Proposal for Supplement 8 to the original version of UN Regulation No. 128 (Light-emitting diodes light sources)

Supplement 8 to the original version of UN Regulation No. 128 (Light-emitting diodes light sources)

Annex 2, amend to read:

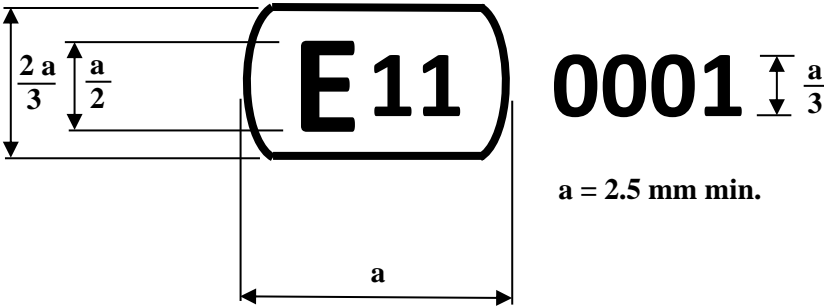
Approval No..... Extension No.....

Approval Code.....
